SUBJECT: Provides addl justification re Section II, Item BB to NRC  
 B60903 responses to SER comments identified in util 80716  
 ltr. Required FSAR change encl.

October 9, 1986  
(NMP2L 0897)

Re: Nine Mile Point Unit 2  
Docket No. 50-410

FIGURE 9.1-5a  
 SPENT FUEL POOL COOLING  
 AND CLEANUP SYSTEM  
 NINE MILE POINT  
 NUCLEAR STATION-UNIT 2  
 FINAL SAFETY ANALYSIS REPORT

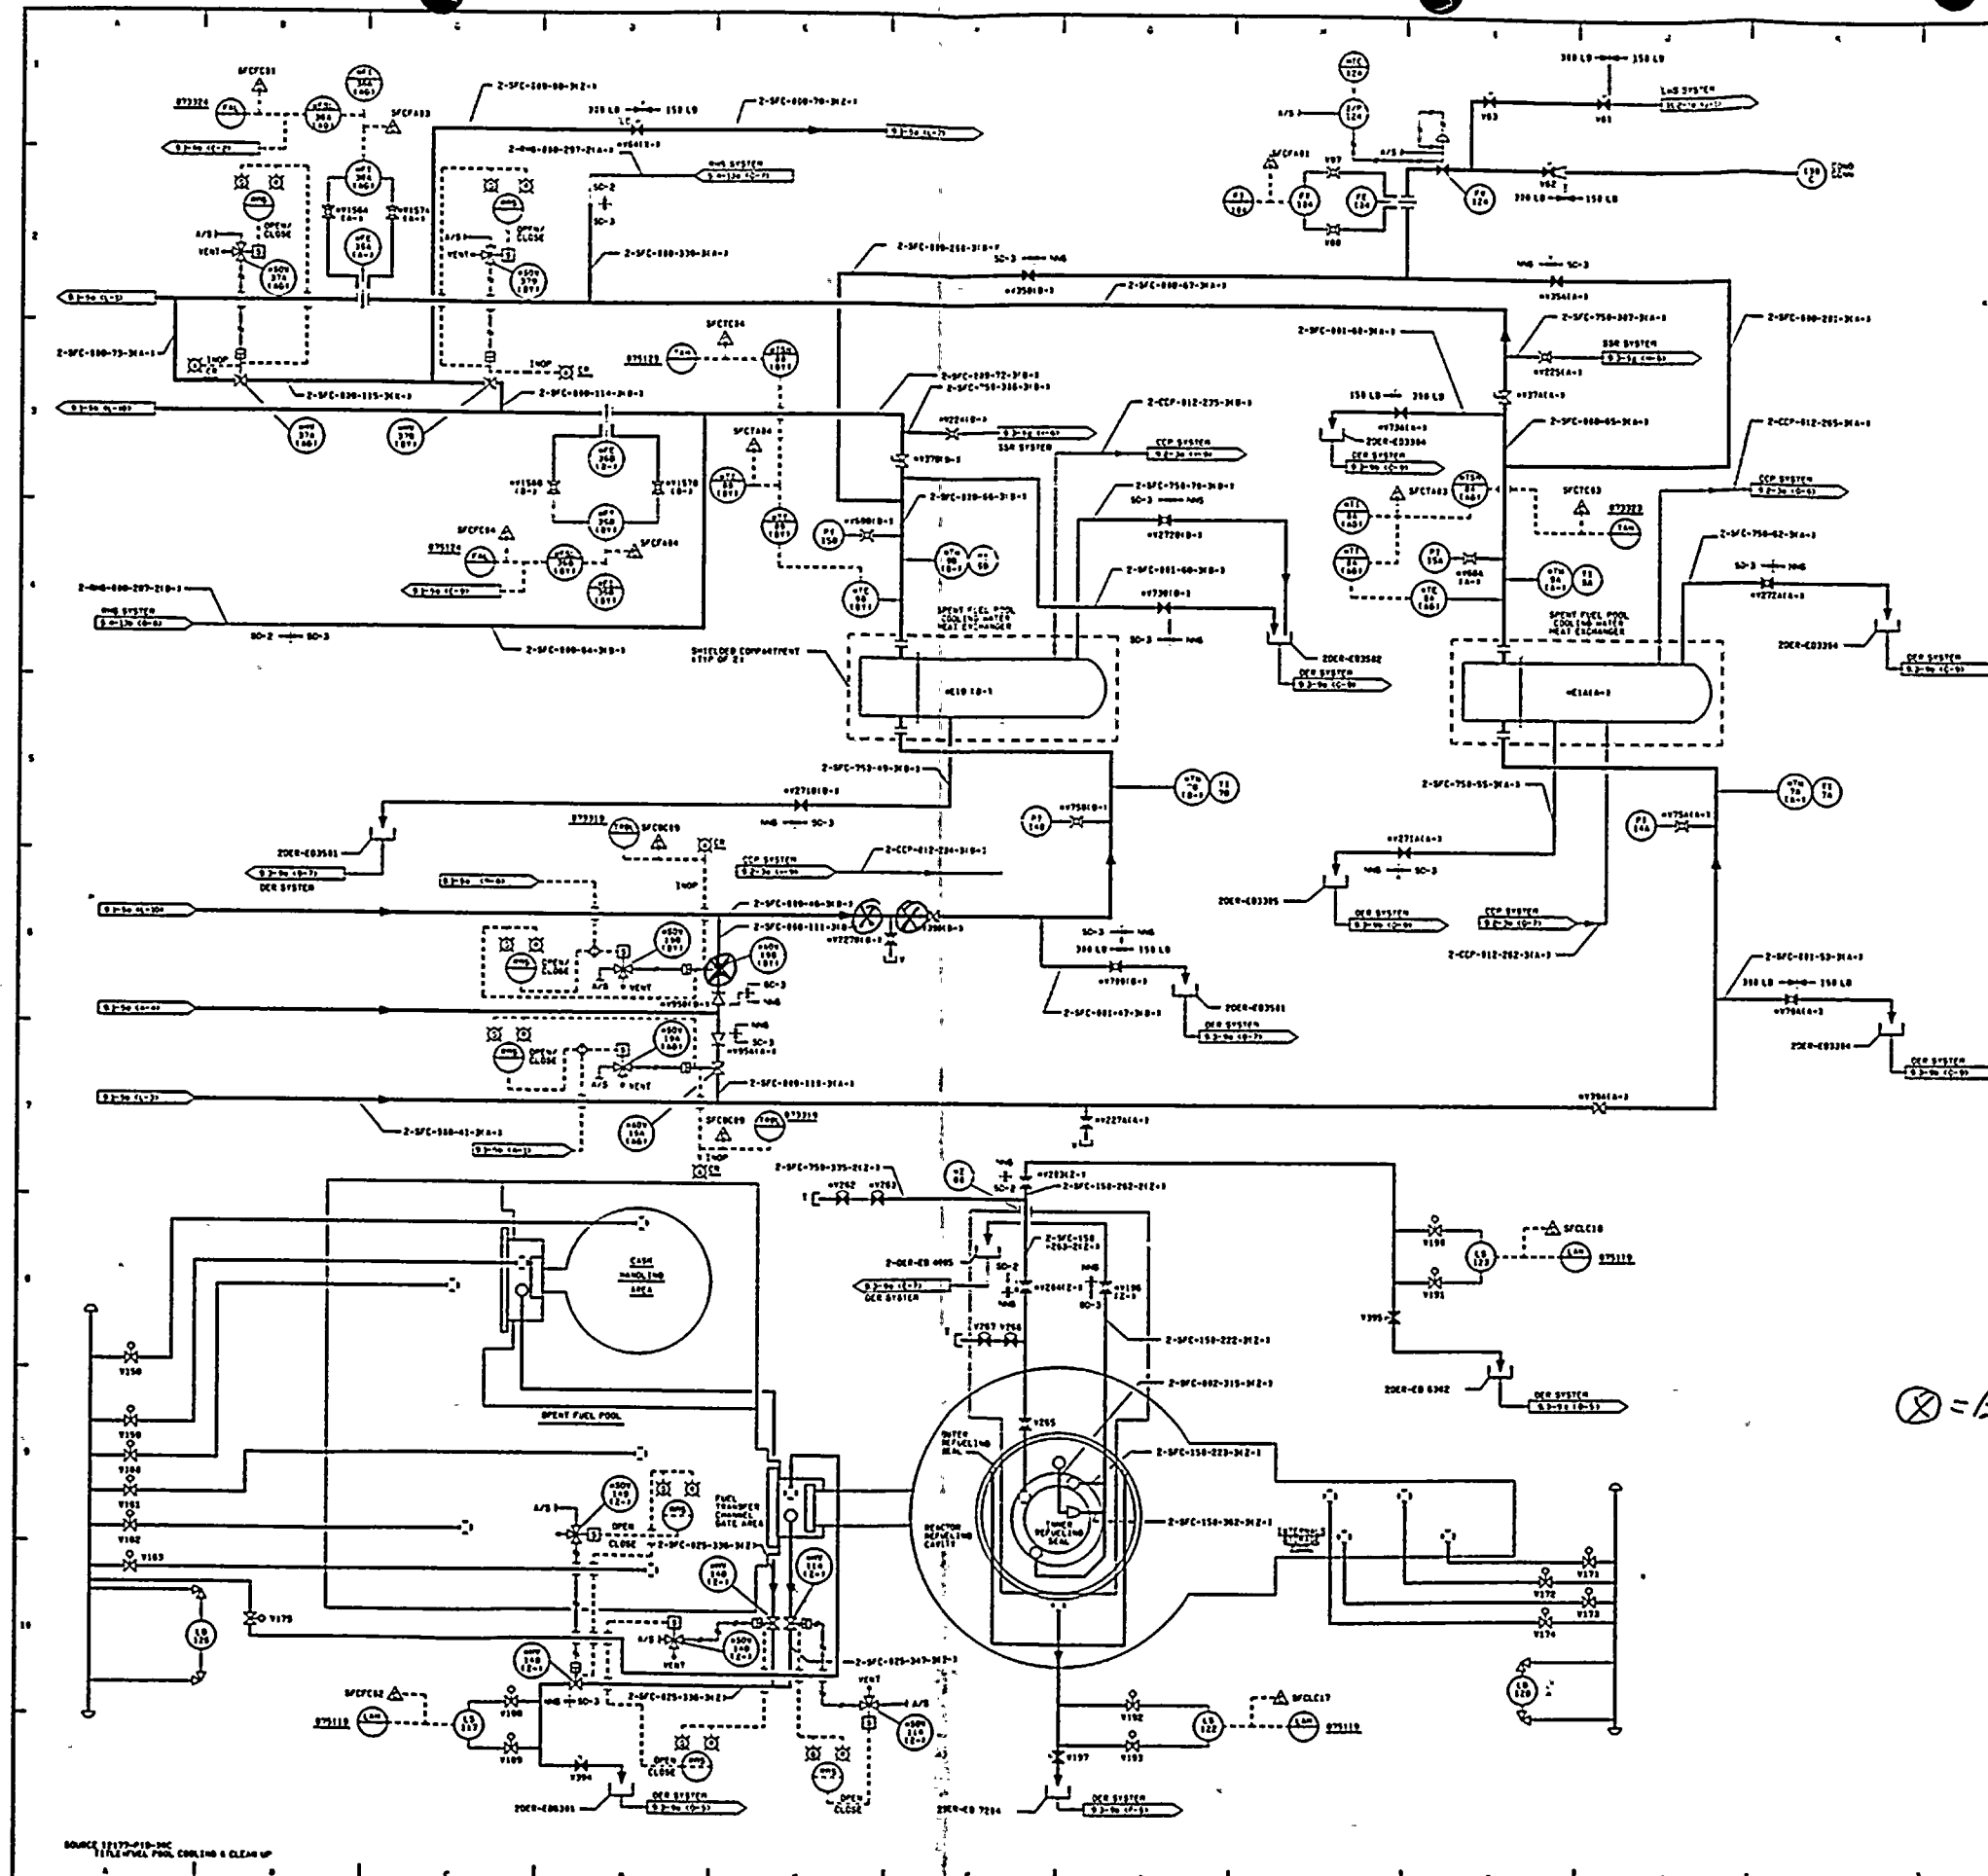
The Amendment 23 FSAR change to 9.1-15 was submitted prior to the completion of the High Energy Line Break (HELB) Analysis. That submittal concluded that at least one loop of the Residual Heat Removal System would be required following a high energy line break. Subsequently, it has been determined that a high energy line break in the spent fuel pool cooling (SFC) area could potentially affect one loop of SFC. However, considering a HELB in the area of one SFC loop and a single failure on the other loop, SFC can still be used to cool the SFC pool. This requires that the Division 1 and Division 2 loops be cross connected. The attached drawings, FSAR Figures 9.1-5a and 9.1-5c, indicate the postulated SFC Targets as a result of the High Energy Line Breaks. This information will not be included in the FSAR and is for information only.
